UNITED STATES PATENT AND TRADEMARK OFFICE

APPLICATION NO.	FILING DATE	FIRST NAMED INVENTOR	ATTORNEY DOCKET NO.	CONFIRMATION NO.
09/804,012	03/12/2001	William R. Bennett	SP-1080.2 US	8880

Office Action Summary

DETAILED ACTION

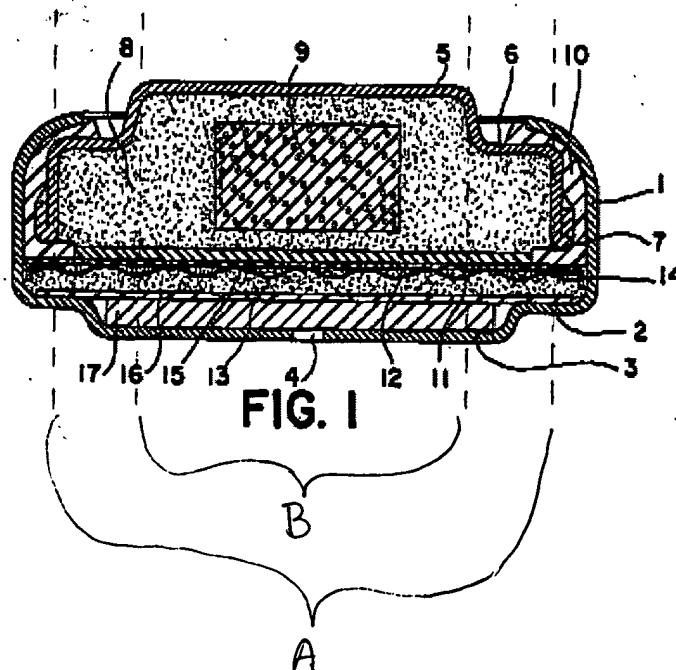
Regarding independent claim 5, Sauer et al. teaches an anode cup having a closed upper end [5], an open lower end [8], a step and a substantially vertical section between the step and the closed end. (Figure 1) Figure 1 is relied upon to teach, by illustration, that the internal diameter [A] of the open end is larger than the maximum external diameter [B] above said step.

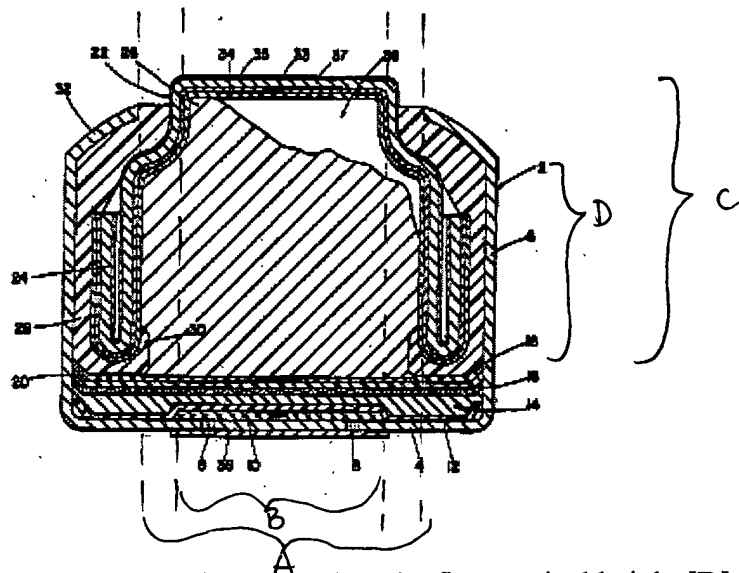
Regarding independent claims 5 and 7, Mansfield, Jr. et al. teaches an anode cup having a closed upper end [37], an open lower end [36], a step and a substantially vertical section between the step and the closed end. (Figure) The Figure is relied upon to teach, by illustration, that the internal diameter [A] of the open end is larger than the maximum external diameter [B] above said step, as illustrated below:

As shown, the second vertical height [C] is greater than the first vertical height [D] and thus the resulting difference would be greater than zero. (independent claim 7)
